Request for Additional Information 564, Supplement 3

Application Title: U. S. EPR Standard Design Certification - Docket Number 52-020

Review Section: 08.02 - Offsite Power System

Question 08.02-8:

Overview U.S. EPR Offsite Power Supply Design for the EATs

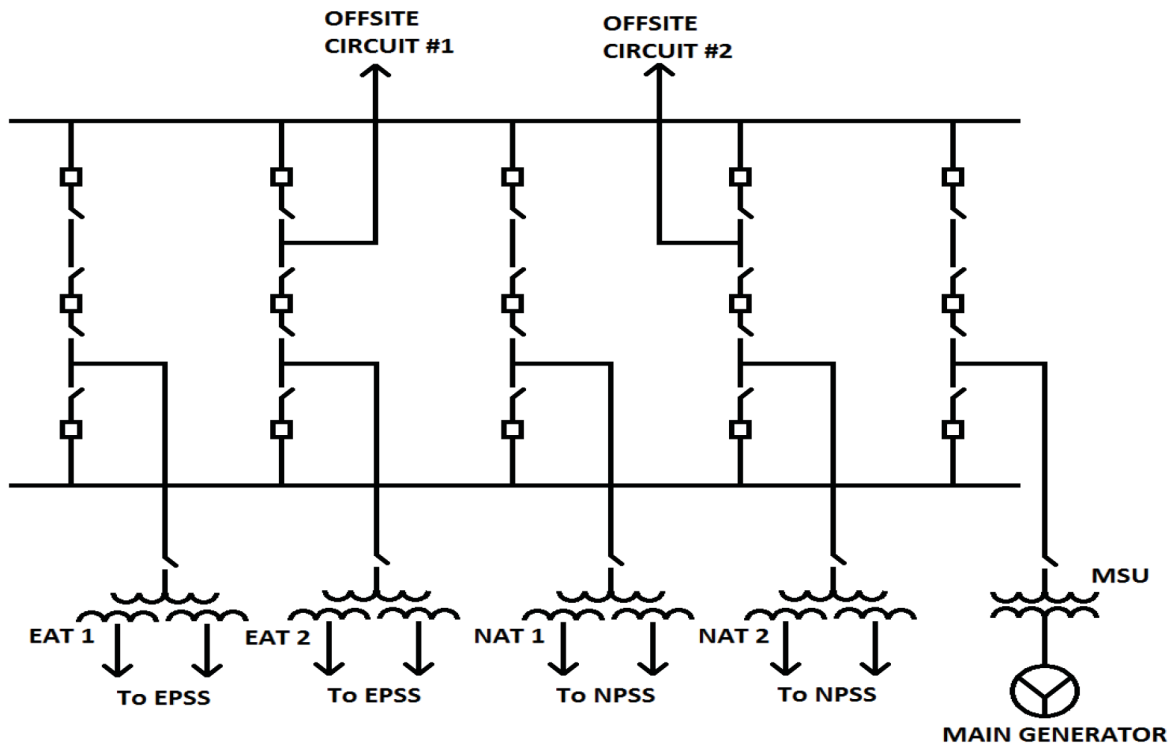
- Describe the protection scheme design for important to safety buses (31-34BDA) to detect and automatically respond to a single-phase open circuit condition or high impedance ground fault condition on credited offsite power circuits.
- If the important to safety buses are not powered by offsite power sources during at power condition, explain how the surveillance tests (e.g., SR 3.8.1.1) are performed to verify that a single-phase open circuit condition or high impedance ground fault condition on an off-site power circuit is detected.
- Describe the plant operating procedures including off-normal operating procedures, specifically calling for verification of the voltages on all three phases of the ESF buses.

The four Class 1E Emergency Power Supply System (EPSS) Buses 31-34BDA of the U.S. EPR design are powered from two, 25 MVA, 3-winding Emergency Auxiliary Transformers (EAT), 30BDT01 and 30BDT02. The three windings of each EAT are connected Wye; the primary, high-voltage side neutral is solidly grounded, and the two secondary, low-voltage side neutrals are each high-impedance grounded. Although each EAT has the capacity and capability to power all four EPSS buses (31-34BDA) under all design basis conditions, the normal operating configuration is for each EAT secondary winding to power a single EPSS bus.

The EATs are powered by dedicated off-site feeds that are not used for powering normal operation plant loads such as RCPs, Main Feedwater Pumps, etc. The Normal Auxiliary Transformers (NATs) supply the normal operations plant loads and have their own dedicated off-site power feeds. The U.S. EPR electrical system configuration also assures that should a loss of phase occur on one of the off-site feeds, the emergency buses and associated safety equipment powered by the second off-site feed are unaffected.

The U.S. EPR electrical system off-site power supply design provides a stable, dedicated and voltage regulated power source for the Emergency Buses. This configuration presents a somewhat unique relaying design challenge when trying to monitor for loss of a single off-site power supply phase due to the light loading of the EATs during normal at-power operation. This normal

operating configuration maintains the EATs very lightly loaded, roughly estimated at 5 to 8 MVA each.
